SLIGHTLY STEEPER APPROACHES CONSULTATION RESPONSE DOCUMENT

Heathrow Slightly Steeper Approaches – Consultation Response Document

TITLE	Slightly Steeper Approaches Consultation Response
STATUS	Final
CLASSIFICATION	Public
AUTHOR	Heathrow
DATE	16/06/2021
VERSION	2.0

Figure 2 Key themes within responses (Do not support SSA)

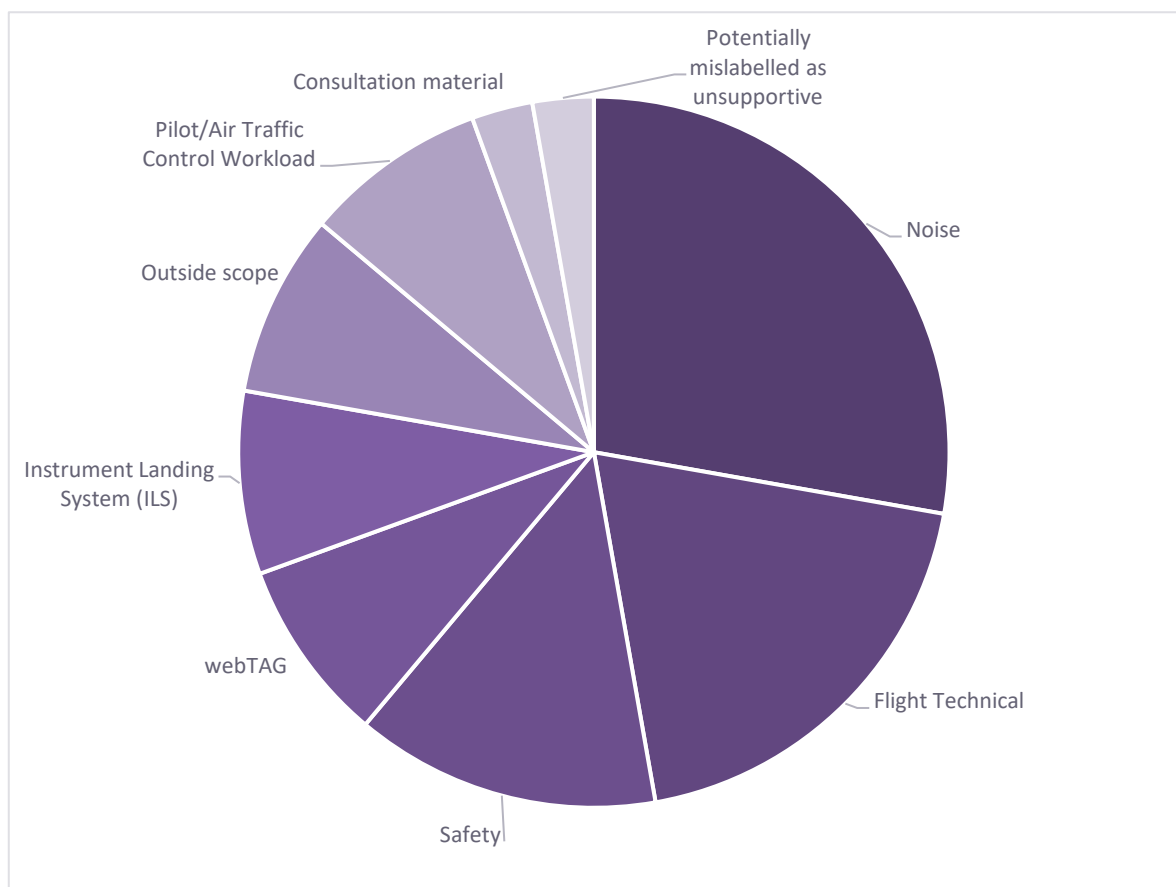
- 3.1.19 Figure 2 below shows the key themes that were highlighted within the qualitative feedback provided in response to question 7 and question 8 that relate to SSA:

Figure 3 Key themes within responses (Support SSA)

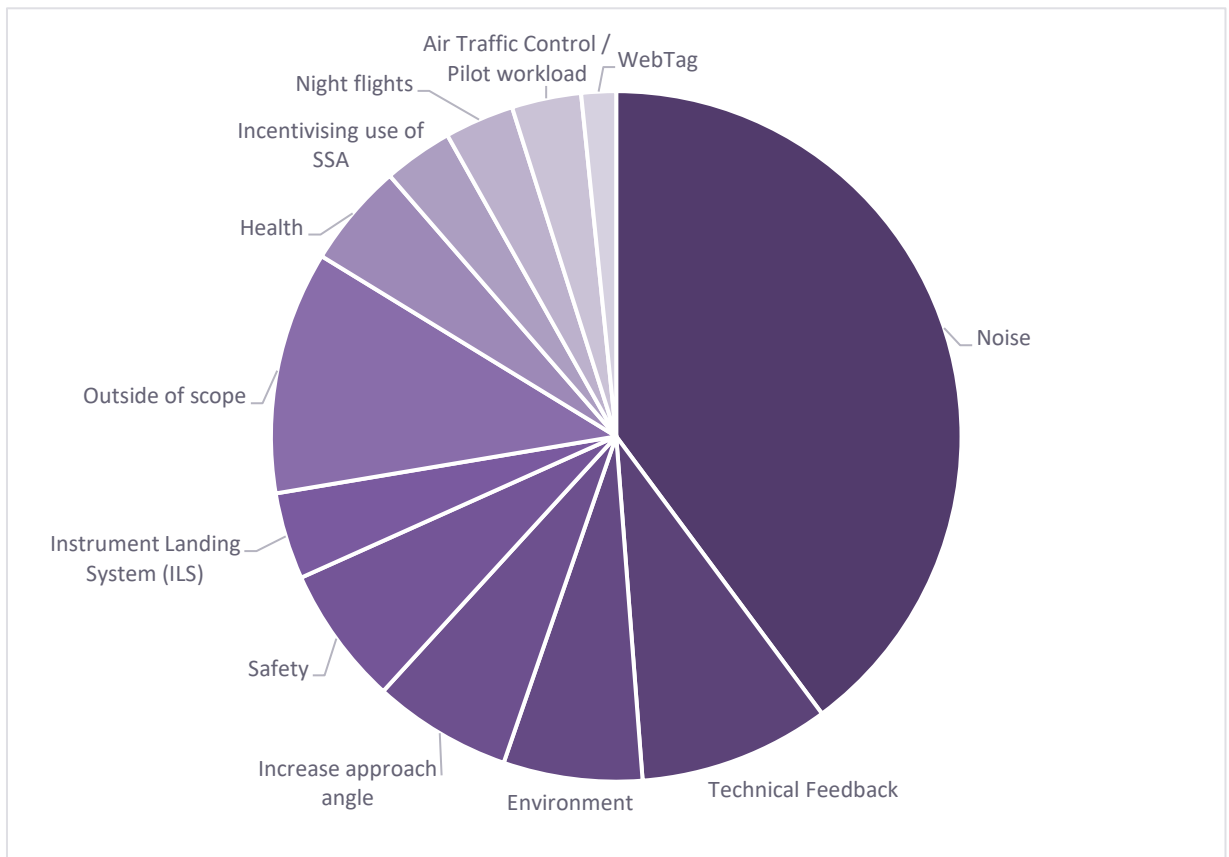
- 3.1.25 Figure 3 below shows the key themes that were highlighted within the qualitative feedback provided in response to question 7 and question 8 that related to SSA:
